PLANNING REPORT & STATEMENT OF CONSISTENCY

APPLICATION FOR PLANNING PERMISSION AND RETENTION PERMISSION FOR A LARGE SCALE RESIDENTIAL DEVELOPMENT (LRD) COMPRISING AN AMENDMENT TO A PERMITTED STRATEGIC HOUSING DEVELOPMENT (SHD) GRANTED UNDER SHD REF. ABP-310299-21

TOM PHILLIPS + ASSOCIATES
80 Harcourt Street
Dublin 2
D02 F449

ROYALTON DEVELOPMENTS DUBLIN 4 LTD
22 The View, Marina Village,
Malahide
Dublin
K36 CX99

Figure 4.1: Extract from PLUS Architecture "Proposed Stair - External - Segregated Bike Access" Drawing, indicating design modifications to comply with DAC and Part M. (Source: PLUS Architecture Dwg. No. BRA-PLA-Z1-ZZ-DR-A-0708P, 2024.)

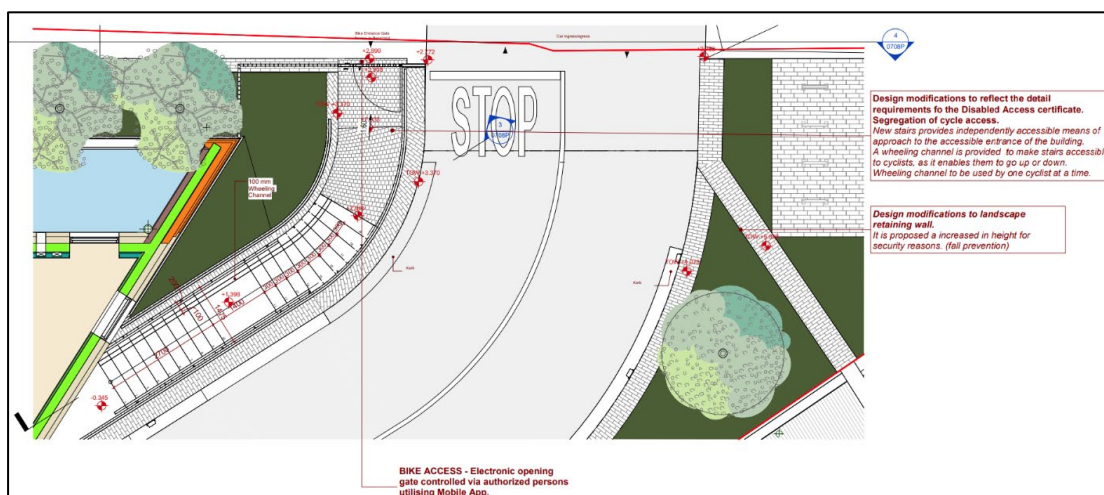
The basement vehicular ramp has been modified to comply with DAC and Part M (vertical clearance to allow the passage of high top vehicles). A segregated cyclist access has been provided, the access comprises a stairs with wheel channel for bikes. There will be a gated access to that stair at the back of the pavement which is accessible to residents via an app, and visitors with resident assistance. The provision of a segregated access will provide for a safer route for cyclists and pedestrians to the Basement.

Figure 4.2: Extract from PUNCH Consulting Engineers "Vehicle Swept Path Analysis Fire Tender" Drawing, indicating section of the roadside barrier on Church Avenue to be removed. (Source: PUNCH Consulting Engineers Dwg. No. BRA-PUN-PA-00-DR-C-D2-0605, 2024.)

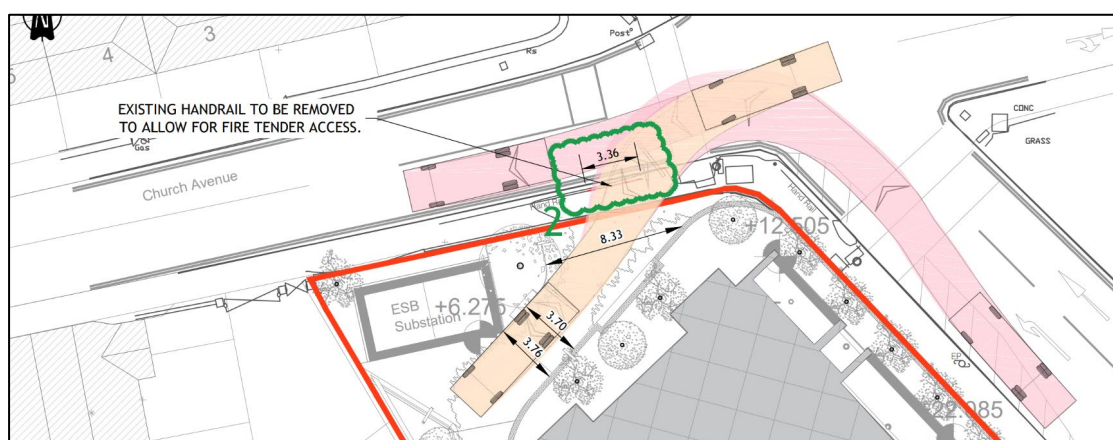
There are existing pedestrian barriers at Church Avenue to the north of the subject site. Irrespective of other alterations proposed in this Application, a portion of the barrier is proposed to be removed to provide Fire Tender Access to the side / rear of the building. This access would also serve the revised waste collection point.

As a result of the removal of the section of the roadside barrier, the section of the concrete pavement is to be upgraded as part of the access upgrade works.
